SITE PLAN
 BRIDGE NO. SA-20 -
 OVER SANDUSKY RIVER
 SB 53, AND NYC. & ST. L. RR.
 SANDUSKY CO.
 SEC. SAN-20-1762
 SCALE 1" = 20' STA 9'

**Sheets 149 thru 172 superseded by
 sheets 149A thru 172A.** 2-10-56
 Rev. 15-3
 Rev. 3-3

GENERAL PLAN & ELEVATION
& ESTIMATED QUANTITIES
BRIDGE NO. SA-20-180
OVER SANDUSKY RIVER
S.R. 53, AND N.Y.C. & ST.L. RR.

GENERAL PLAN & ELEVATION & ESTIMATED QUANTITIES
BRIDGE NO. 5A-20-180

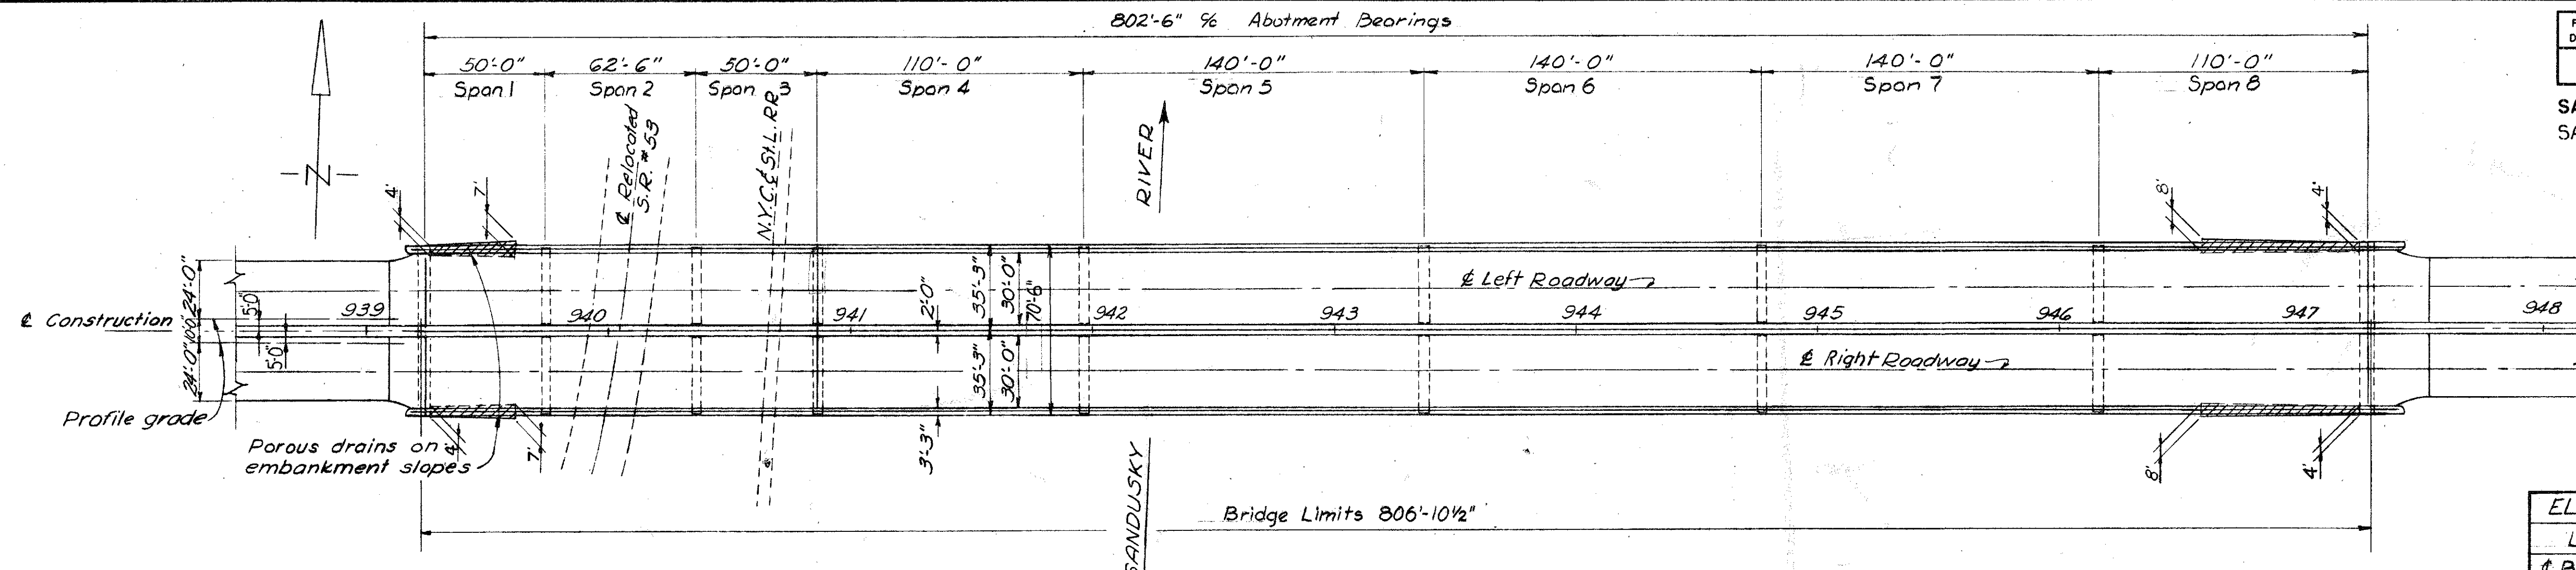
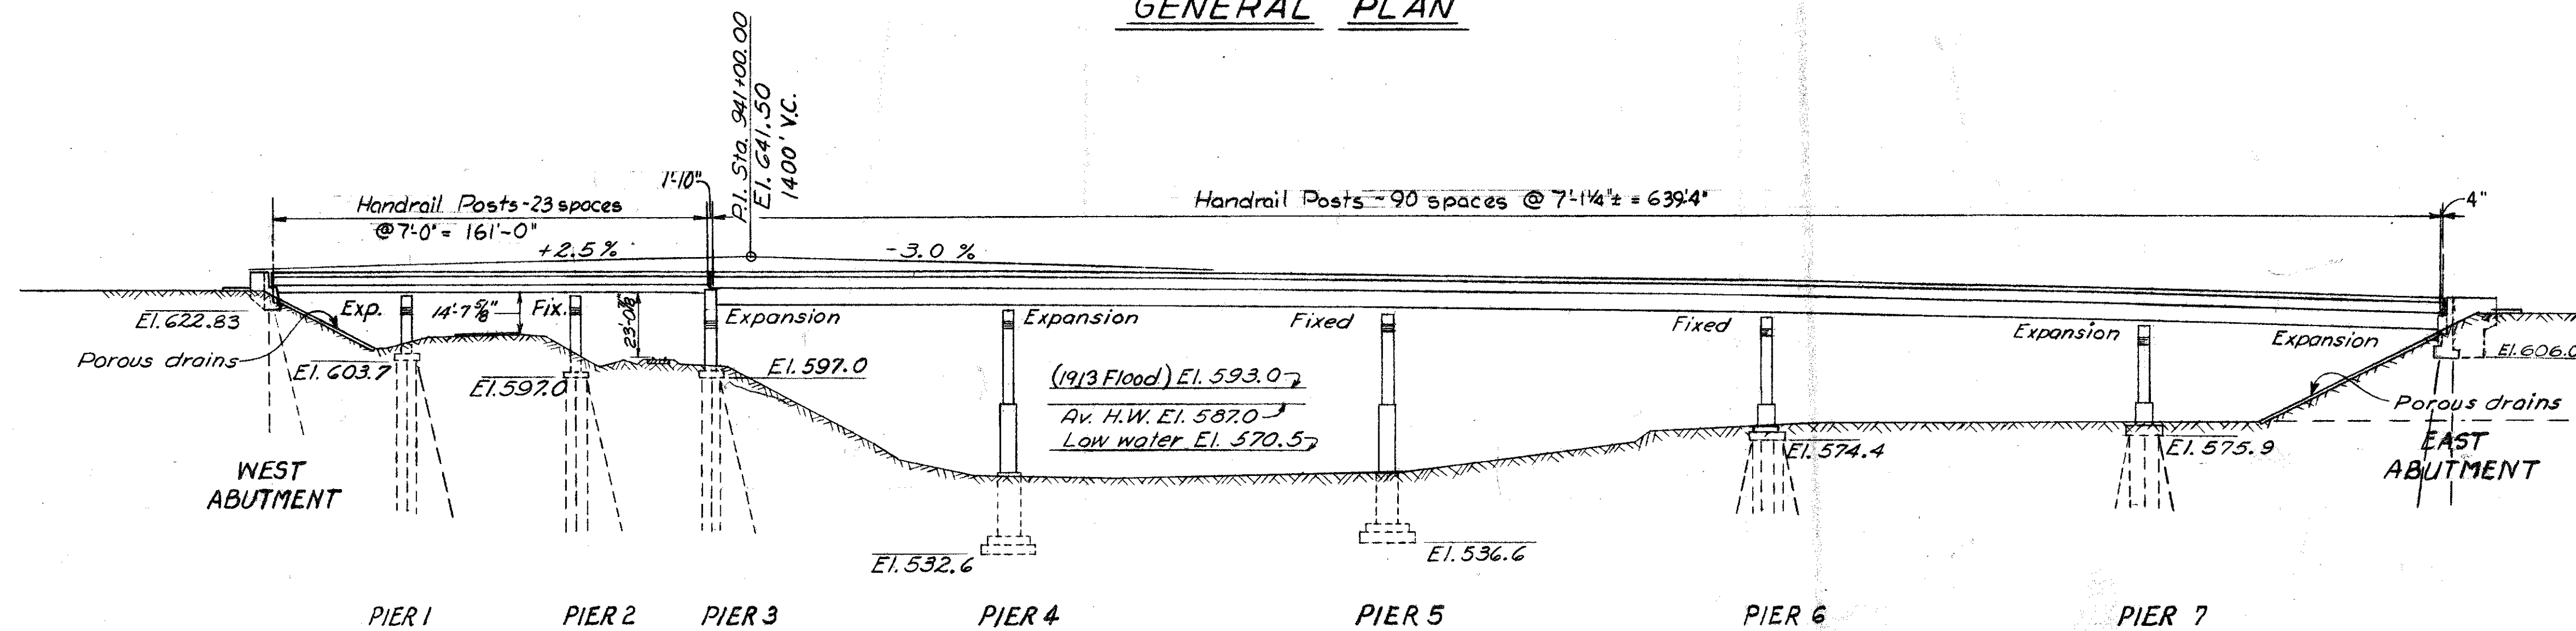
* These changes were made on the original plans. (Sheet 151)

727,847 Plan Quantity
- 7,482 As Built Revisions
720,365 Proposed Quantity (Revised Plans)
703,472 Proposal Quantity
+ 16,893 Change Order Quantity

Item	Total	Unit	Description	Super	W. Abut.	E. Abut.	PIERS							Gen'l.	As Built	
							1	2	3	4	5	6	7			
E-2	3,190	Cu. yds.	Unclassified excavation		62	785	78	747	73	7,240	7,098	781	739		C-23-13	3,190
E-2	90	Cu. yds.	Rock excavation						187	745					C-23-242	90
E-2		Lump Sum	Cofferdams, cribs and sheeting (Pier 4 & 5)											Lump		
E-2		"	" " " " (Pier 1, 2, 3, 6 & 7)											Lump		
S-1	1,911	Cu. yds.	Class "C" concrete, superstructure, including abutment parapets	1,905	2	4									C-15-109*	
S-1	406	Cu. yds.	Class "C" concrete, pier caps on all piers				47	47	64	62	62	62	62		C-22-34*	
S-1	190	Cu. yds.	Class "E" concrete, abutments		90	100									C-22-21*	
S-1	812	Cu. yds.	Class "E" concrete, pier footings				32	36	32	200	200	196	116		C-10-72*	
S-1	95	Cu. yds.	Class "E" concrete, abutment footings		95										C-22-97*	
S-1	583	Cu. yds.	Class "E" concrete, shafts of Piers 1, 2, 3 and upper shafts of Piers 4, 5, 6, and 7.				44	66	67	113	107	99	87		C-22-41*

S-1	477	Cu. yds.	Class "E" concrete, lower shafts of Piers 6 and 7 and intermediate shafts of Piers 4 and 5						190	190	54	43			C-22-15*	
S-1	485	Cu. yds.	Class "E" concrete, lower shafts of Piers 4 and 5						265	220						
S-4	220,365	Lbs.	Reinforcing steel	493,062	4,428	11,219	7,469	9,212	7,974	52,430	59,337	44,741	31,293	646	C-22-16, 233	720,345
S-7	2,581,490	Lbs.	Structural steel	2,581,490						53,578	58,549				C-23-30, 223	2,611,619
S-8	6,581,490	Lbs.	Field painting of structural steel	6,581,490											C-23-30, 223	2,611,619
S-14	1,608	Lin. ft.	Railing, (aluminum rail and supports and concrete parapet)	1,608												
S-16	Lump sum		First test pile											Lump		
S-18	11,153	Lin. ft.	Steel piles, 12BP53		1,374	1,236	6,540	4,472	1,344			2,495	1,500		C-12-72	11,153
S-29	46,522	Cu. yds.	Porous drains on embankment slopes											52	C-23-6	46

EAST ABUT

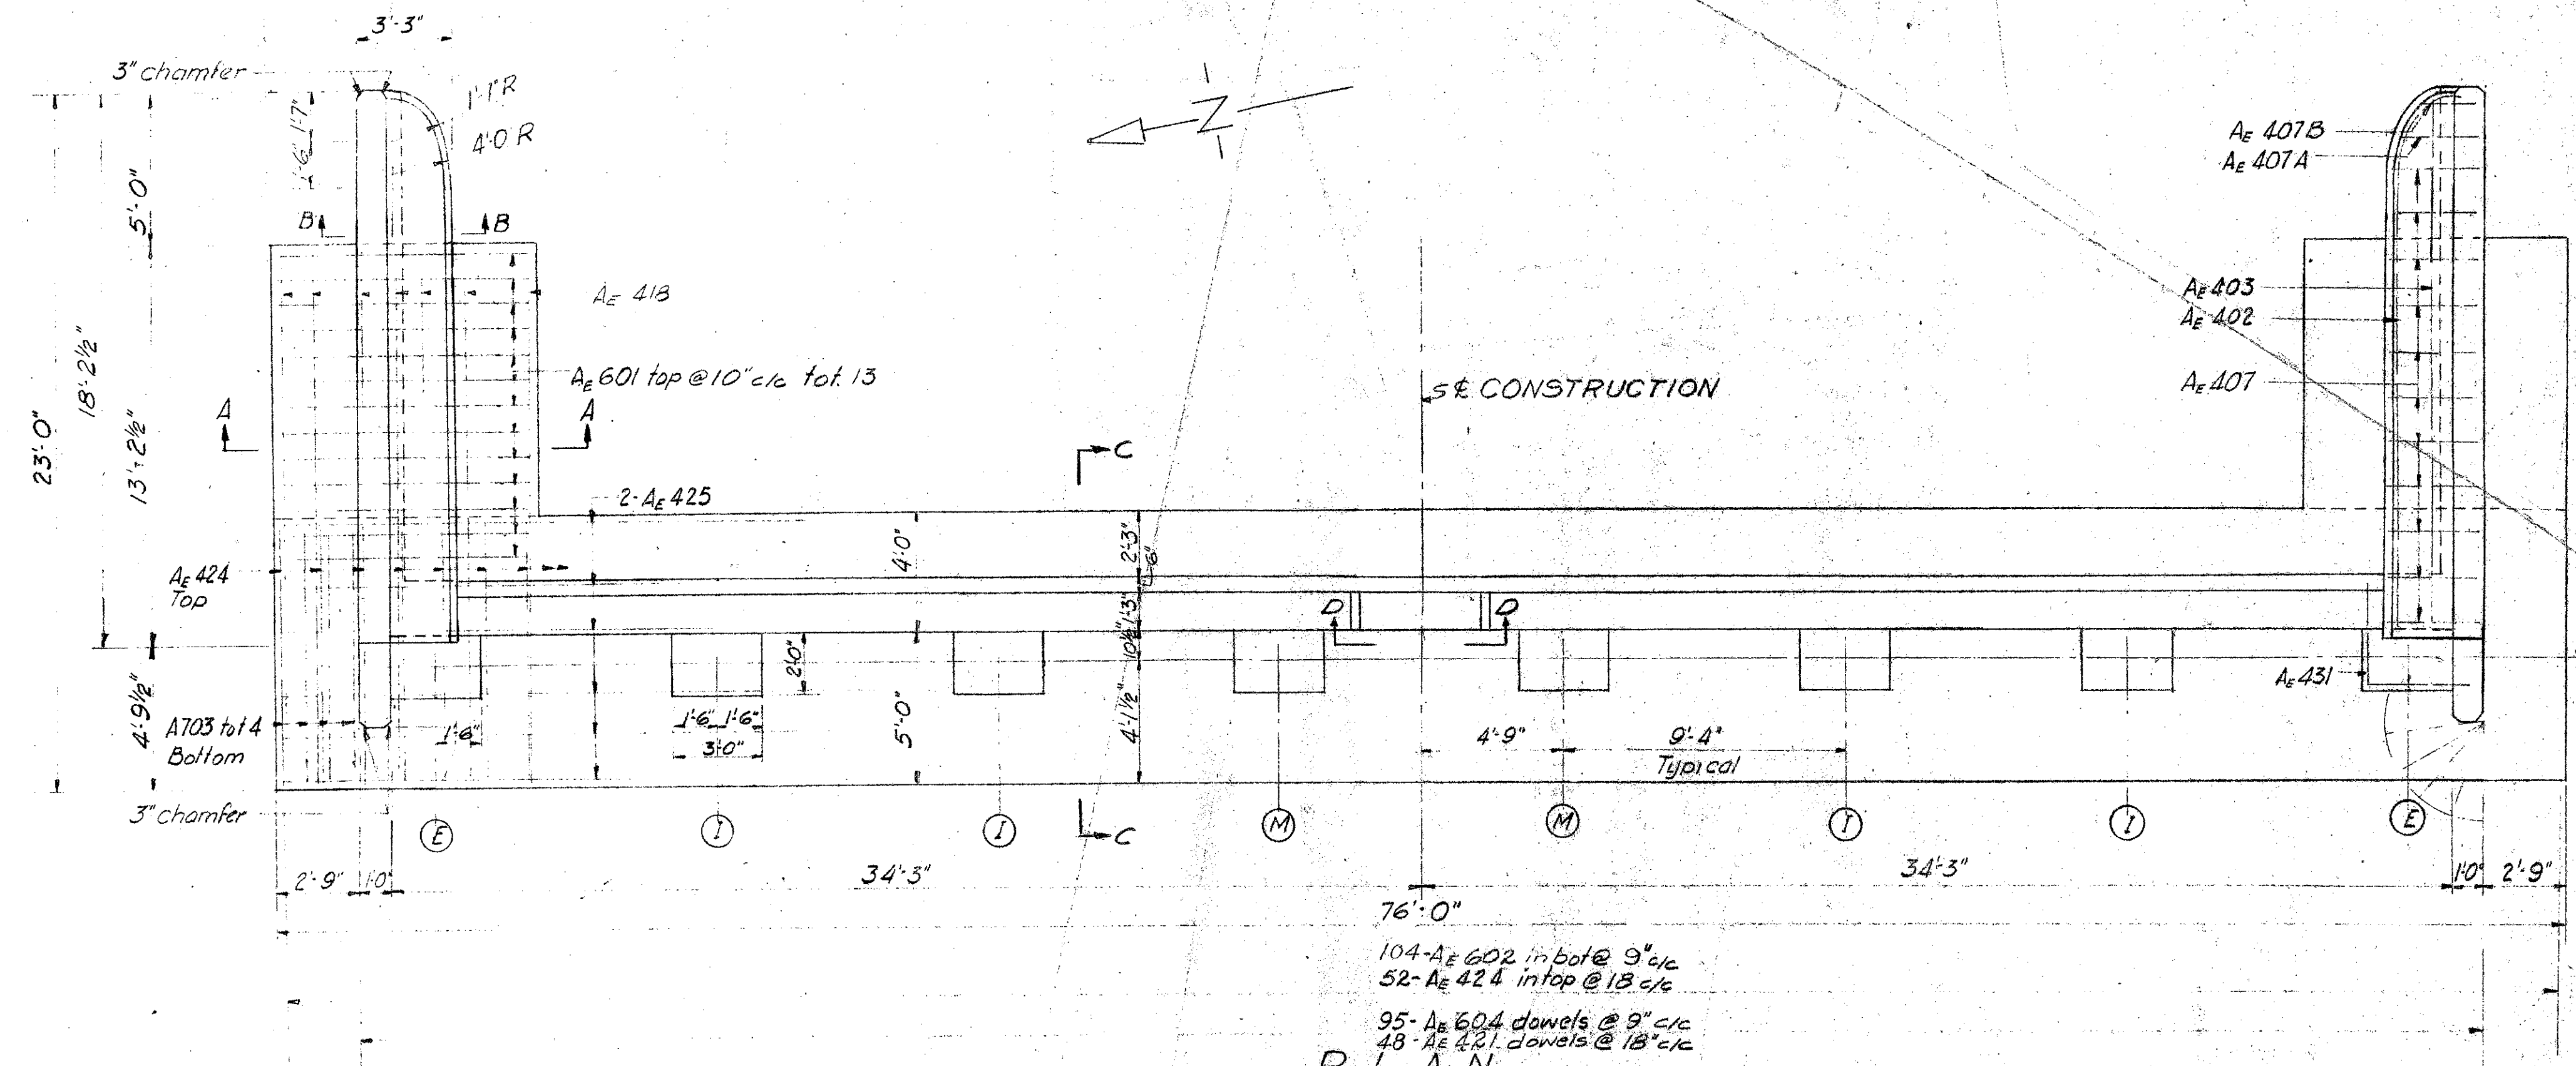
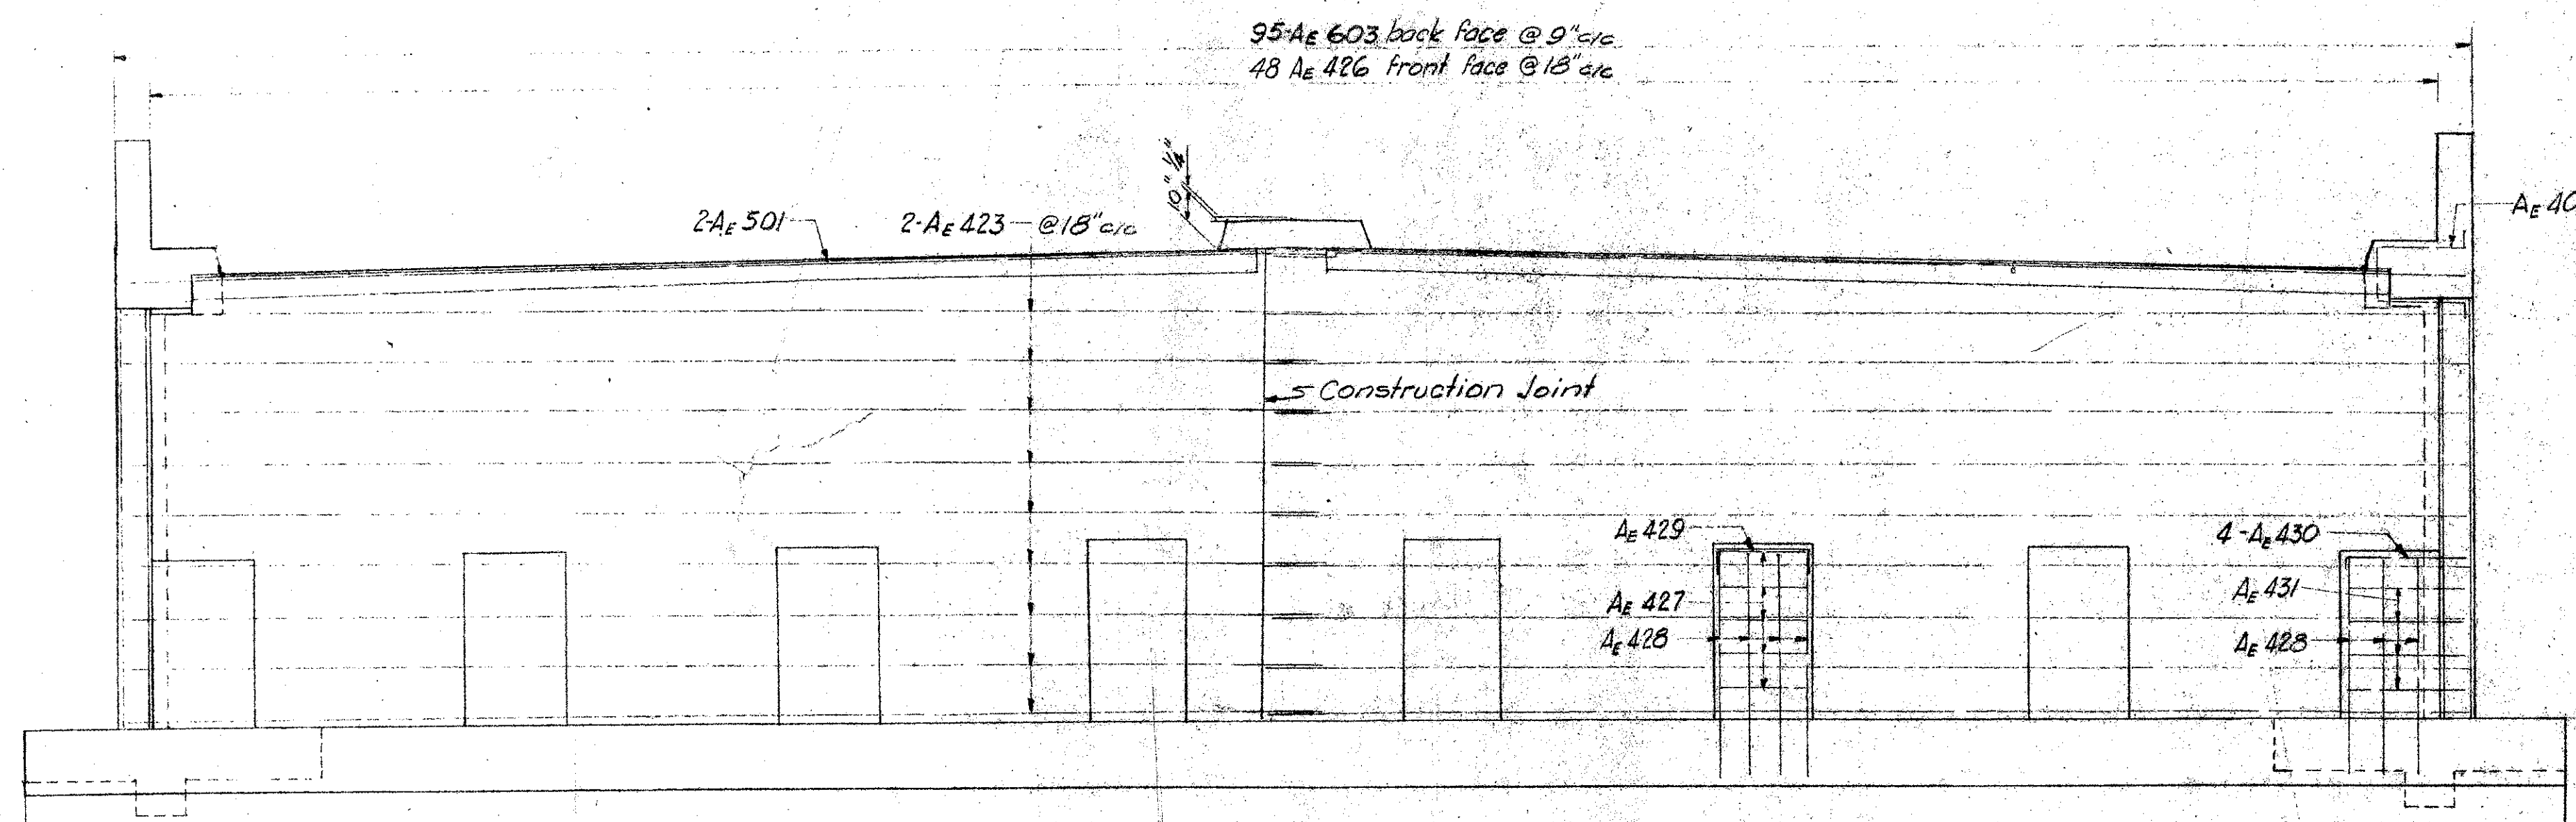
This sheet will be revised redesign of the footing of piling.
